ADDENDUM NO. 2

WASTEWATER TREATMENT PLANT EXPANSION  
KYLE, TEXAS

CONTRACT DOCUMENTS, DRAWINGS AND TECHNICAL SPECIFICATIONS

P:\PR55768\Cadd\Sheets\112 SECURITY FENCE DETAILS 2 PH2.dwg 10/14/2019 9:21:07 AM Doss, Colleen

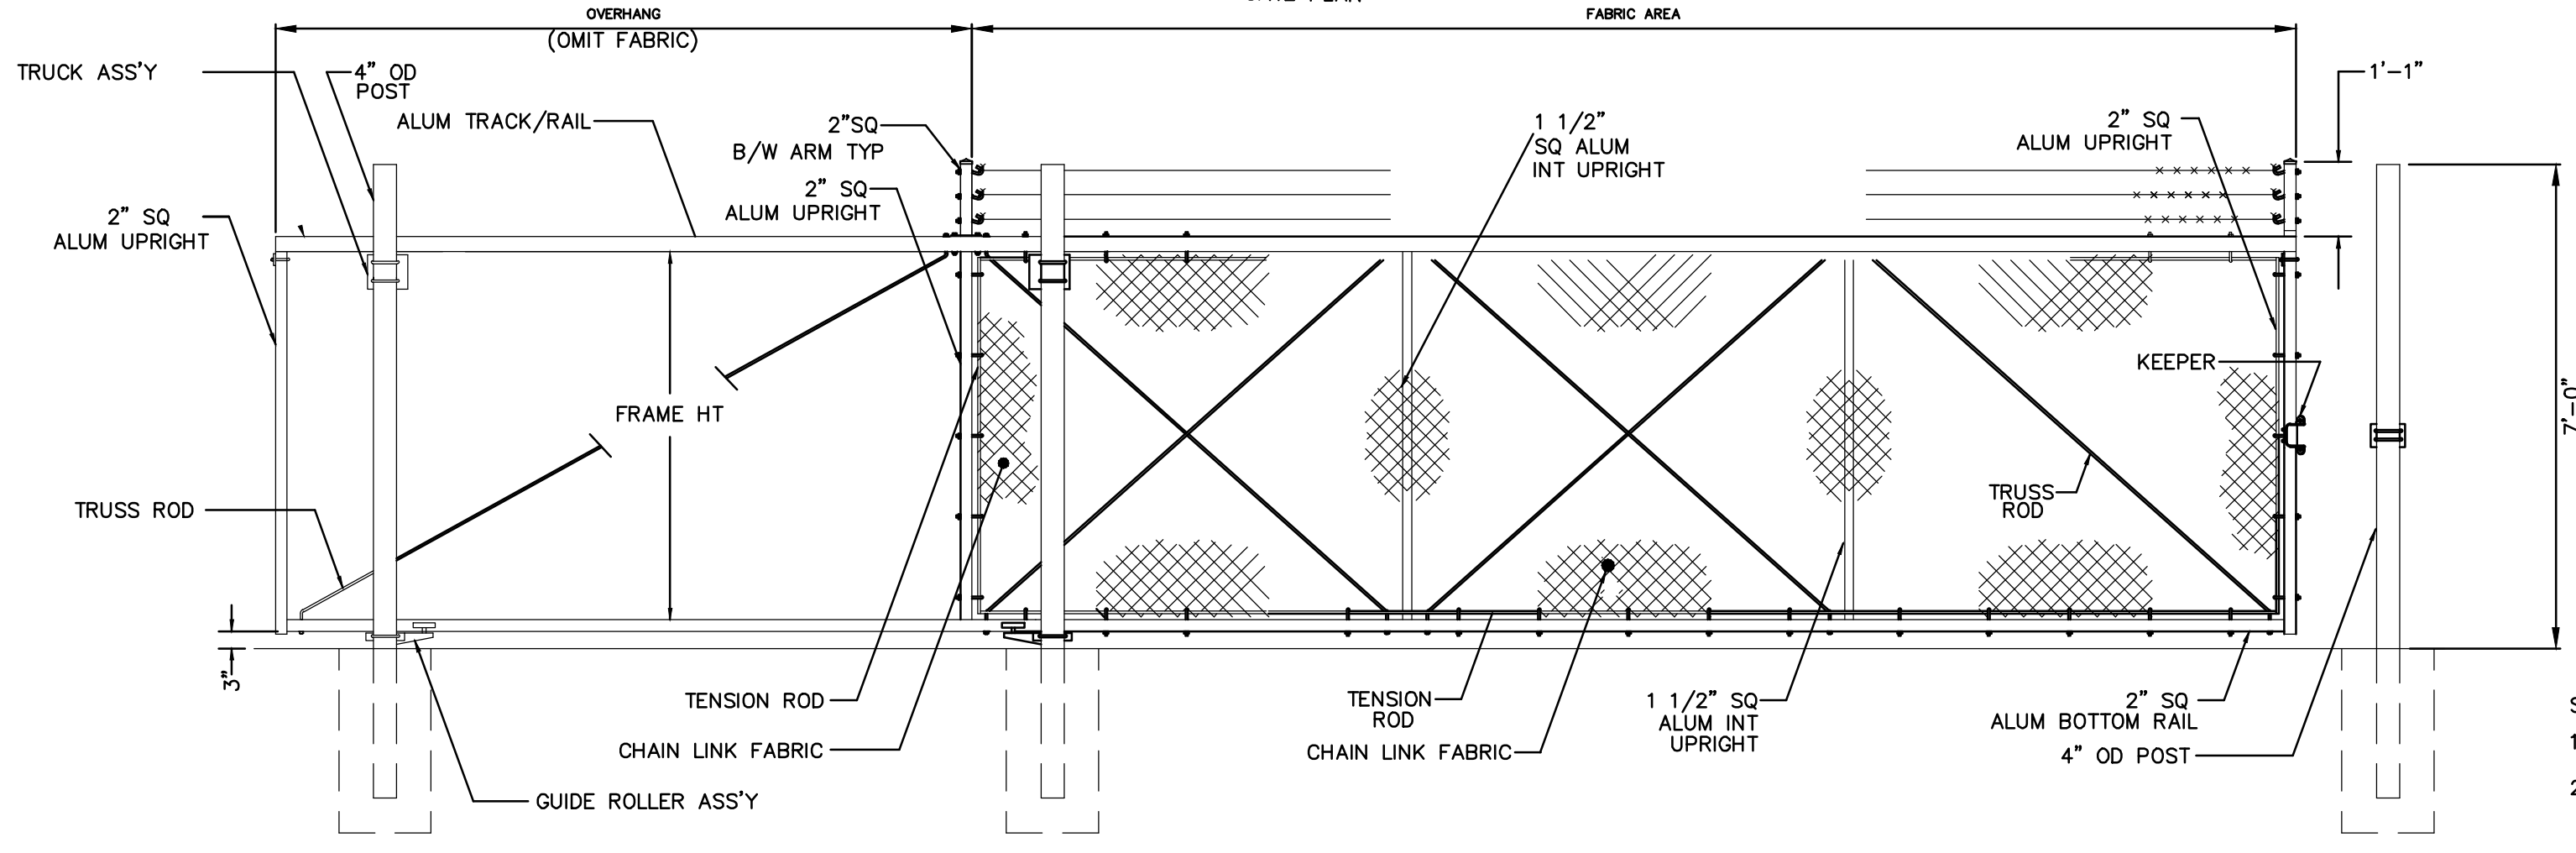
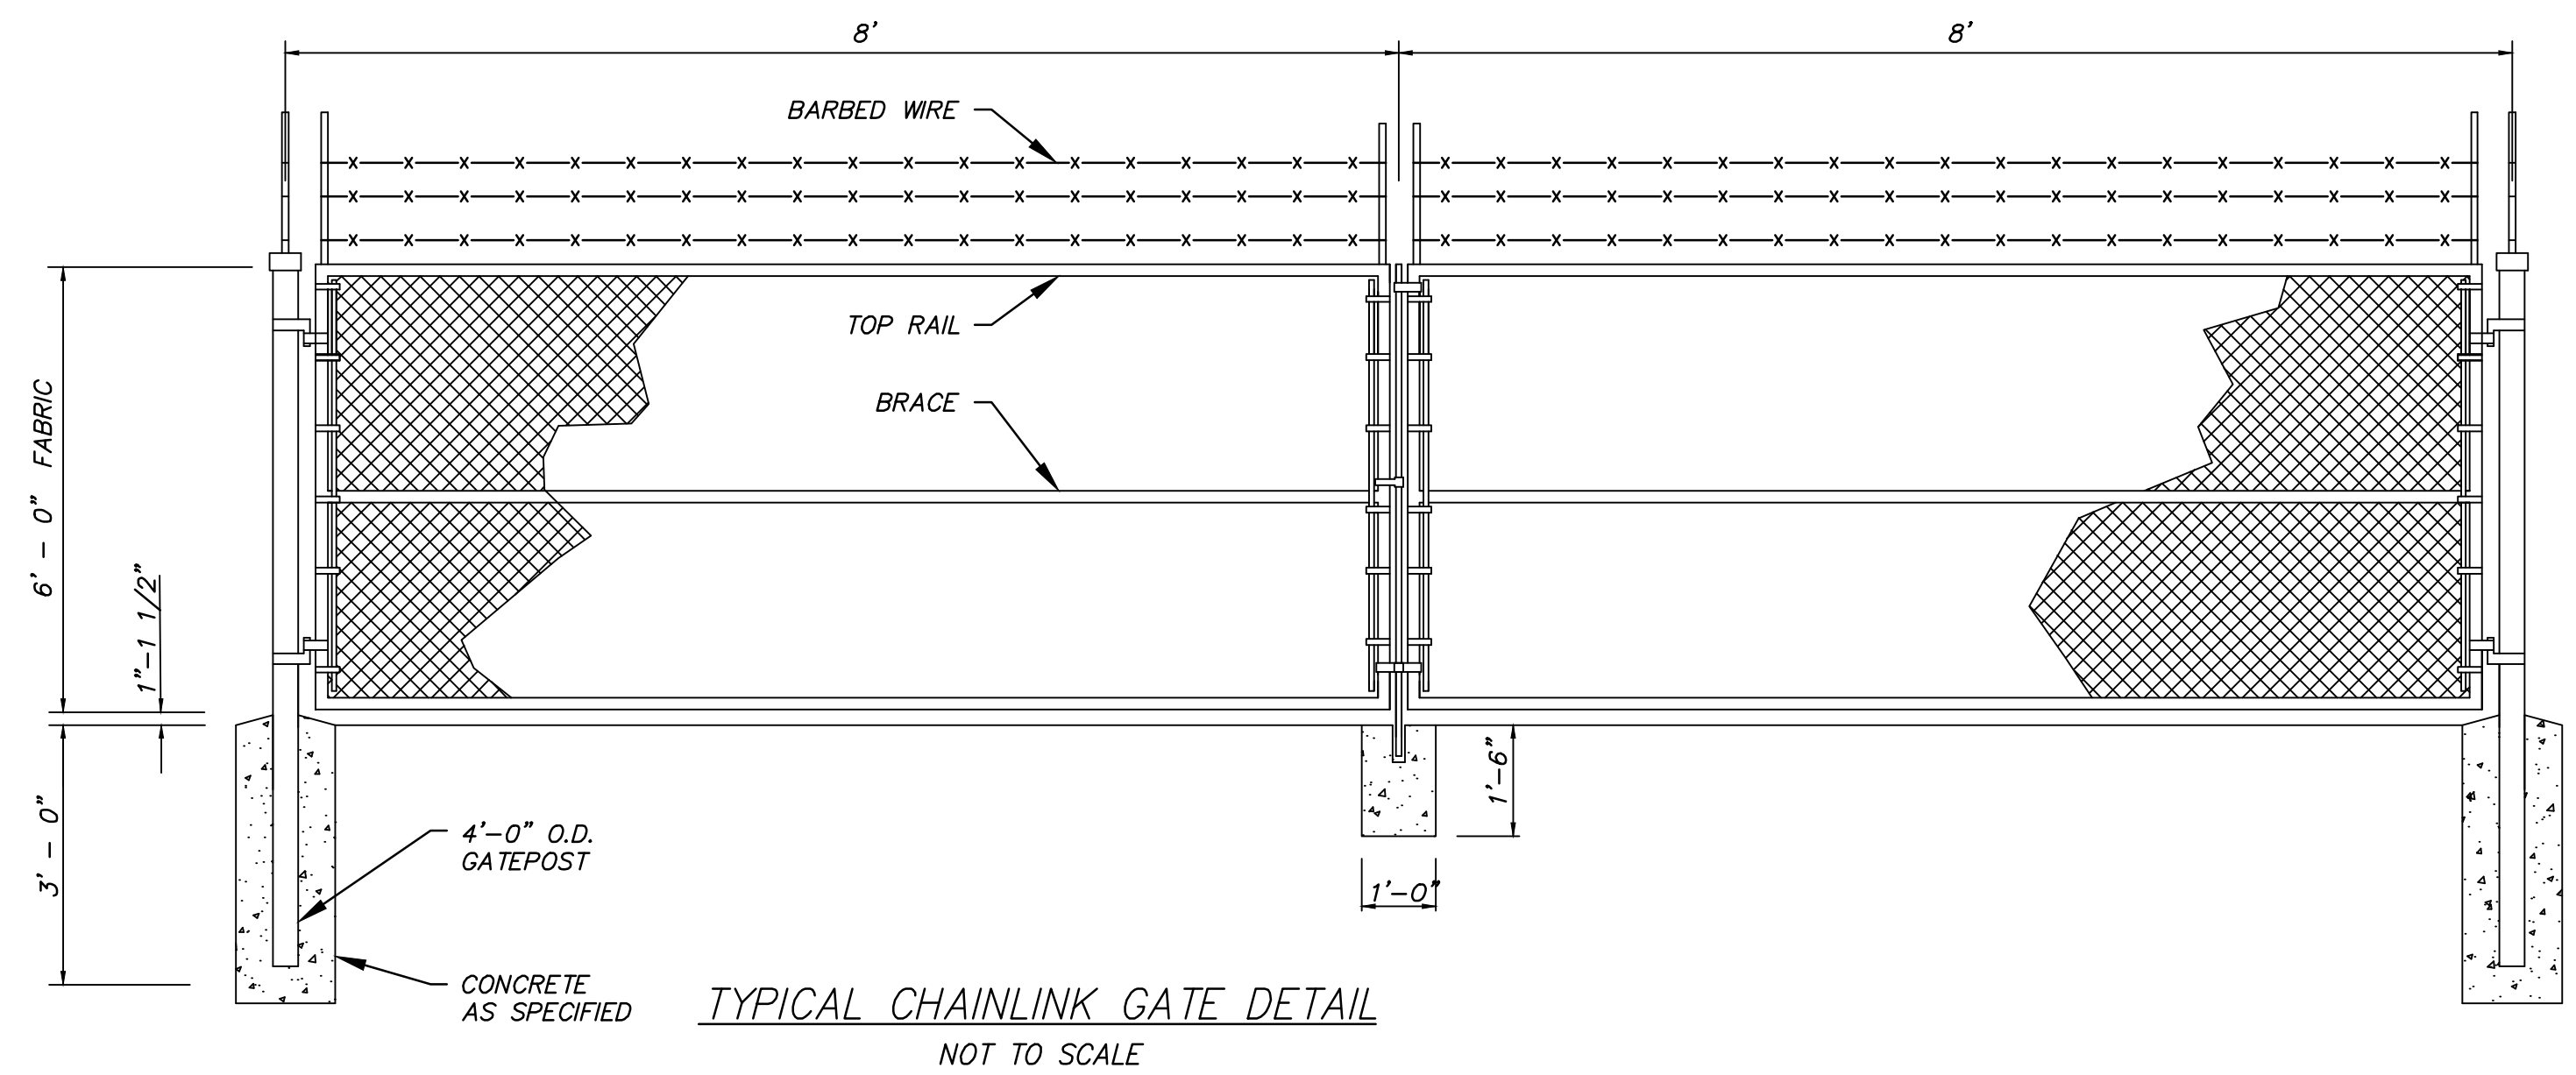
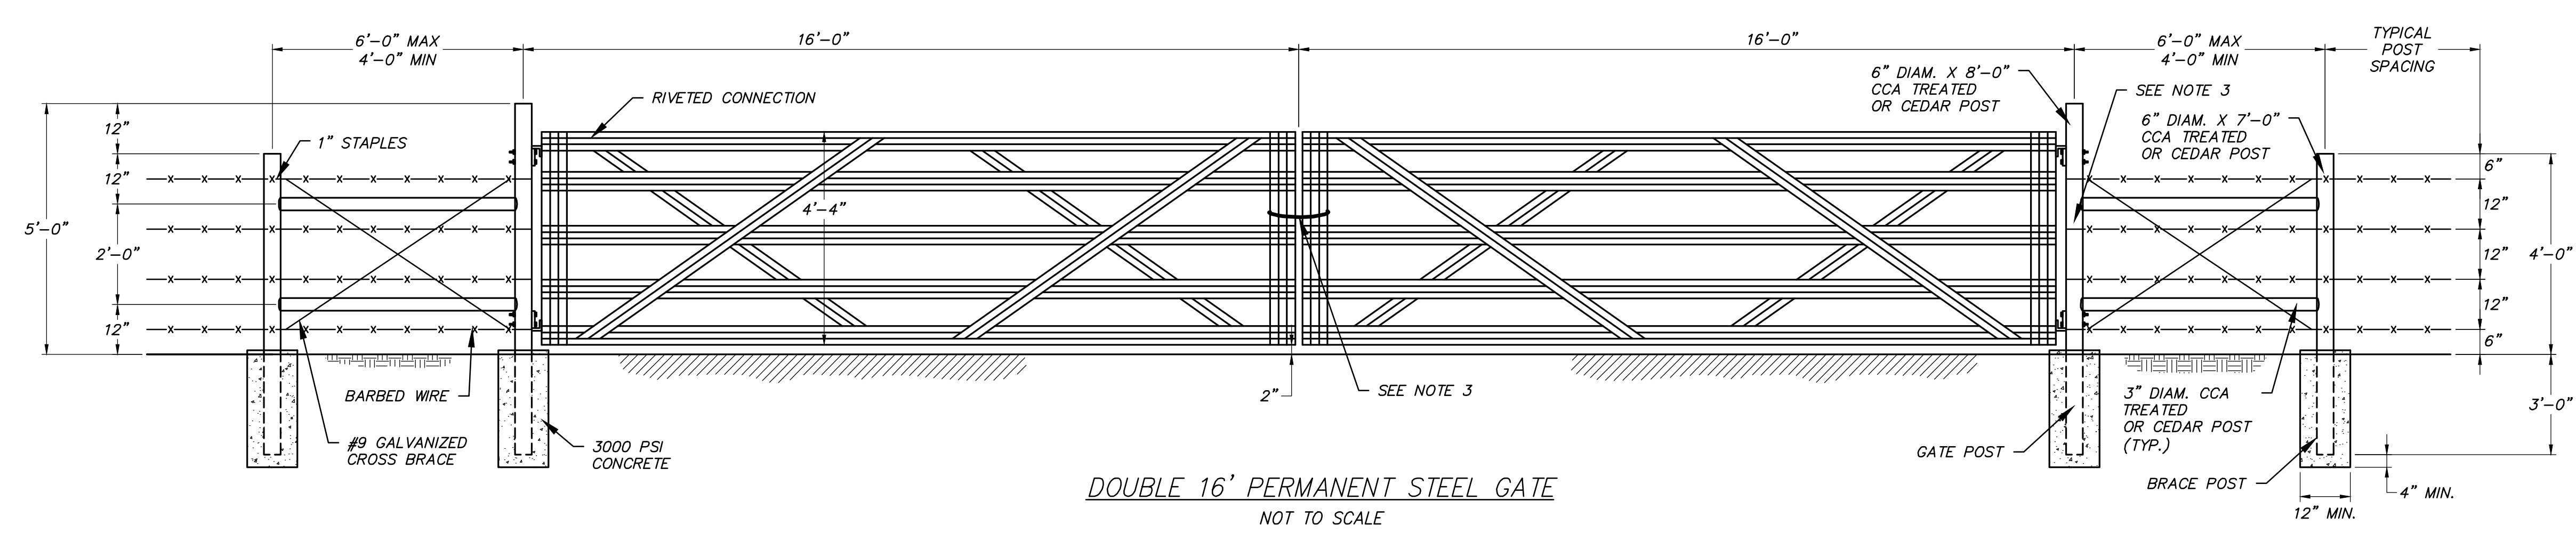
- 46      **Question:**      Can a detail/elevation be provided for the automatic slide gate shown on sheet 13?
- Answer:**        For both slide fence gates indicated on Sheet 13, [see revised Sheet 112 issued as part of this addendum.](#)
